**International
Aero Engines**

V2500 Propulsion System — Nacelle

Subject: Transmittal of Revision 3 to Service Bulletin Number V2500-NAC-78-0140

NACELLE - EXHAUST - CASCADE-TO-AFT CASCADE SUPPORT RING ATTACHMENT -
MODIFICATION OF

Thrust Reverser Cascade Attachment Modification
Figure 1

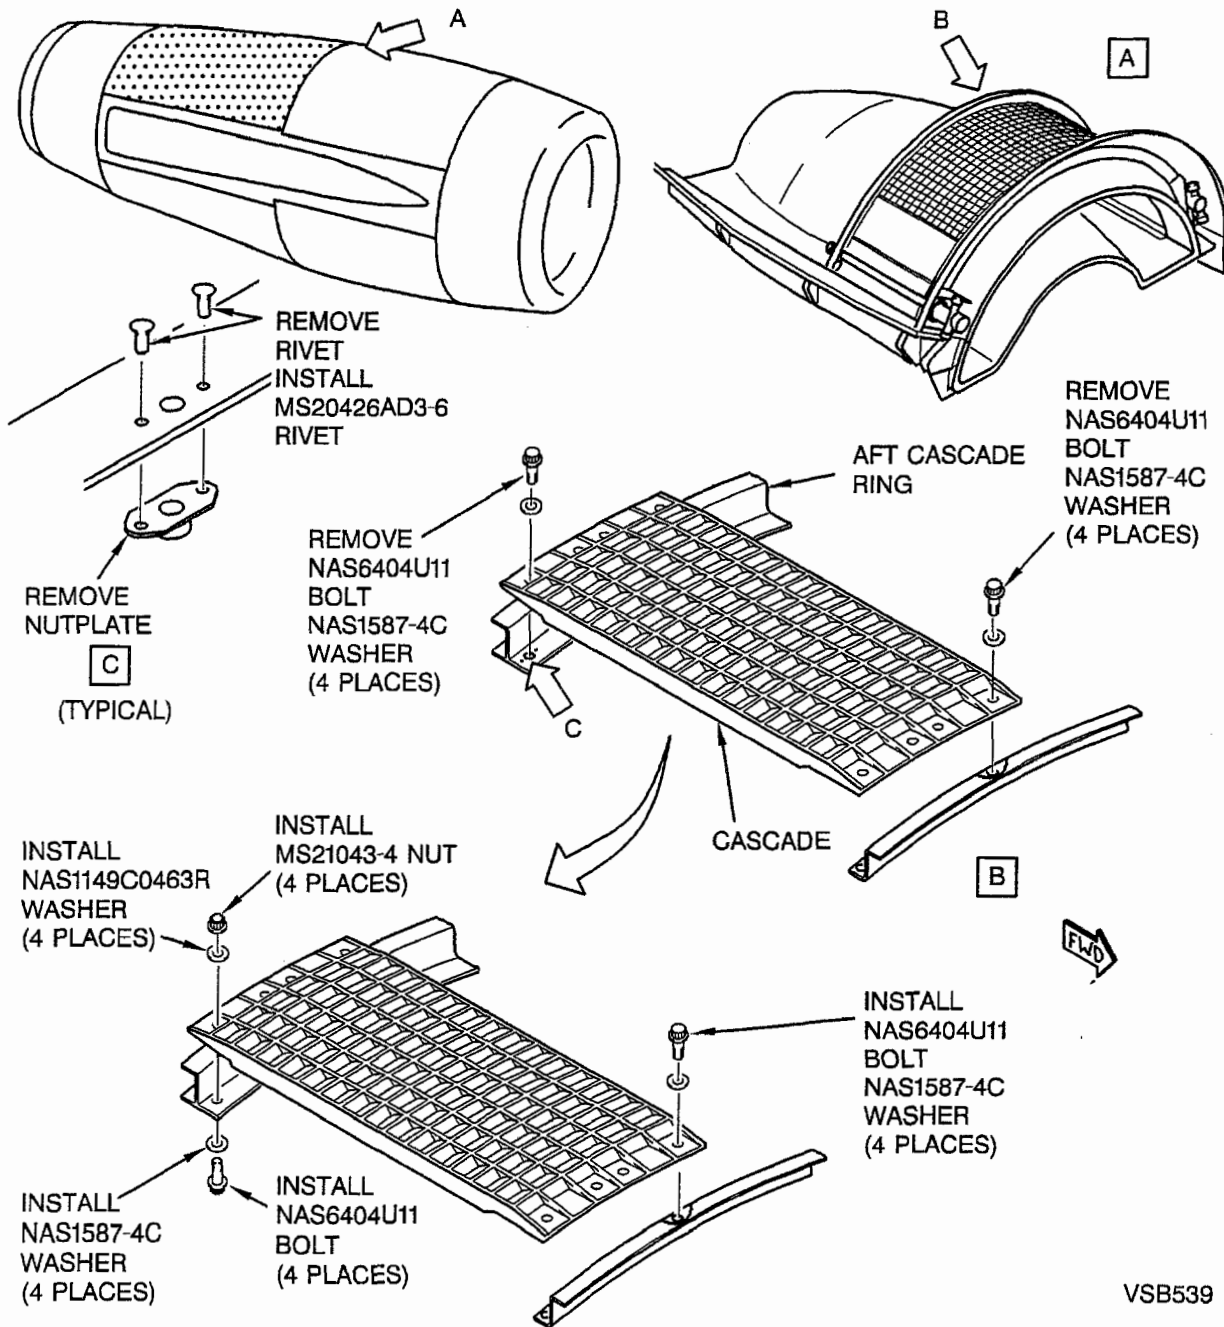
The thrust reverser cascade-to-aft cascade ring attach bolts have been found to interfere with the inner surface of the translating sleeve bond panel during certain phases of aircraft operation.

Modify the cascade-to-aft cascade ring installation to eliminate interference with the translating sleeve bond panel.

The thrust reverser cascades are removed. The cascade attach nutplates are removed from the aft cascade ring. The nutplate attach rivet holes are filled with rivets. The translating sleeve bond panel is examined for damage caused by the cascade attach bolts. Any damage is repaired. Then the cascades are installed and attached to the aft cascade ring with bolts, washers, and nuts.

- (1) Inspect the translating sleeve bond panel for damage caused by interference with the cascade attach bolts. Refer to Figure 1.
- (2) If damage is found, repair as follows:

- (7) Install the cascades and blank cascades.
 - a. At the forward end, attach each cascade or blank cascade with four NAS1587-4C washers and four NAS6404U11 bolts. Refer to Figure 1.

- b. At the aft end, attach each cascade or blank cascade to the aft cascade ring with four NAS6404U11 bolts, four NAS1149C0463R washers, four NAS1587-4C washers, and four MS21043-4 nuts. Install the bolts with the heads inboard as shown in Figure 1.

- c. Torque the NAS6404U11 bolts and the MS21043-4 nuts to 50-70 in-lbs (5.7-7.9 Nm).

Translating Sleeve Bond Panel Bolt Interference Damage Repair
Figure 2 (Sheet 4)

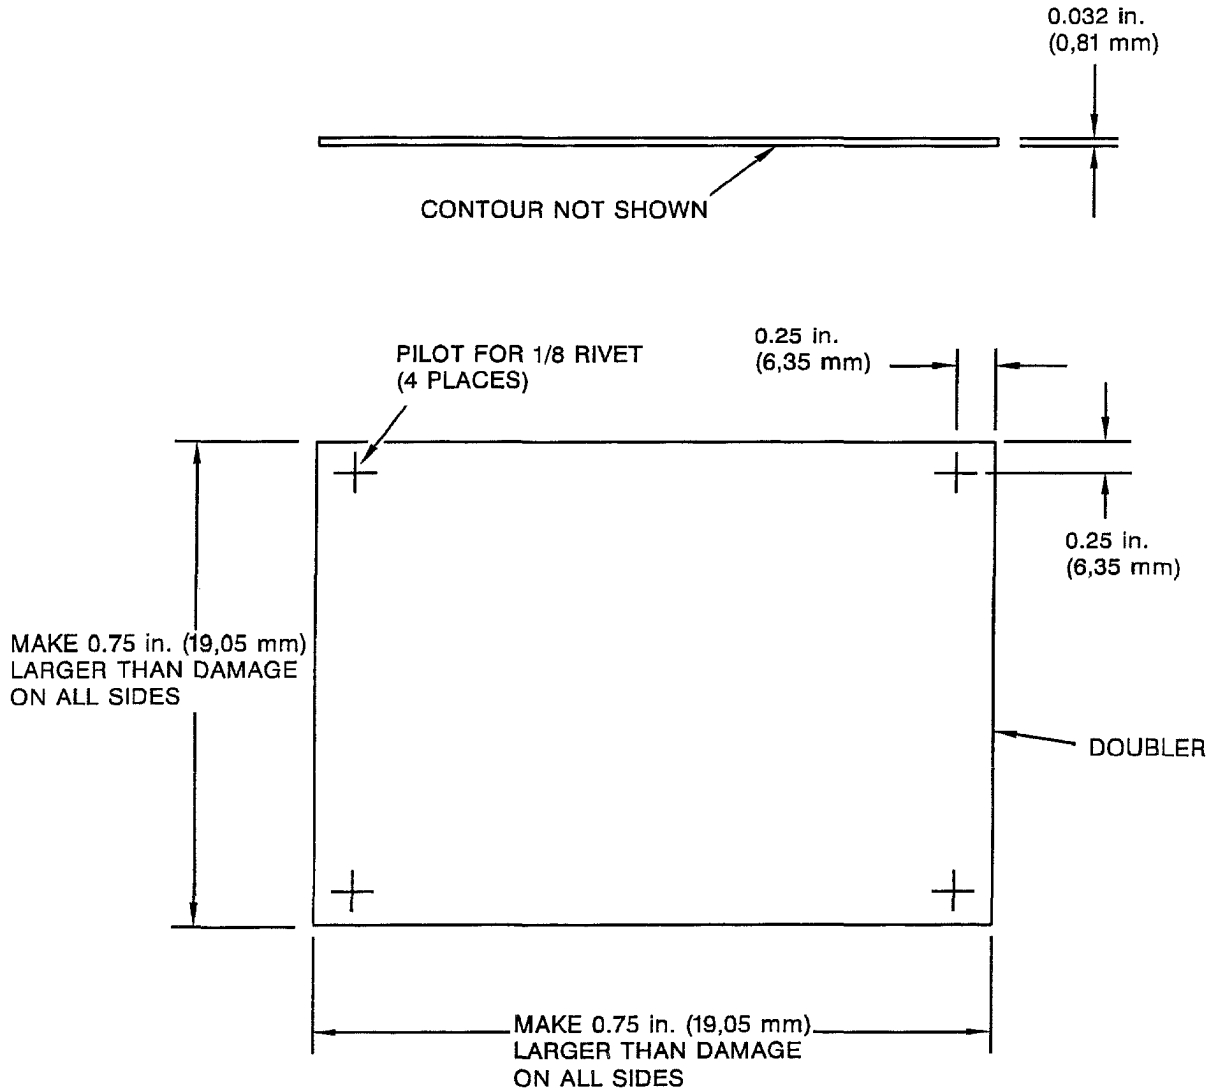
NOTE: ONE DOUBLER CAN COVER
DAMAGE CAUSED BY TWO
ADJACENT BOLTS.

- c. Make the repair doublers from .032 inch thick 2024-T3 material. Form the doublers to match the contour of the skin in the repair area. Make the mating surface of the doublers rough with silicon carbide abrasive paper (CoMat 05-081). Drill pilot holes for CR3243-4-1 rivets at each corner of the doublers. Refer to Figure 2.
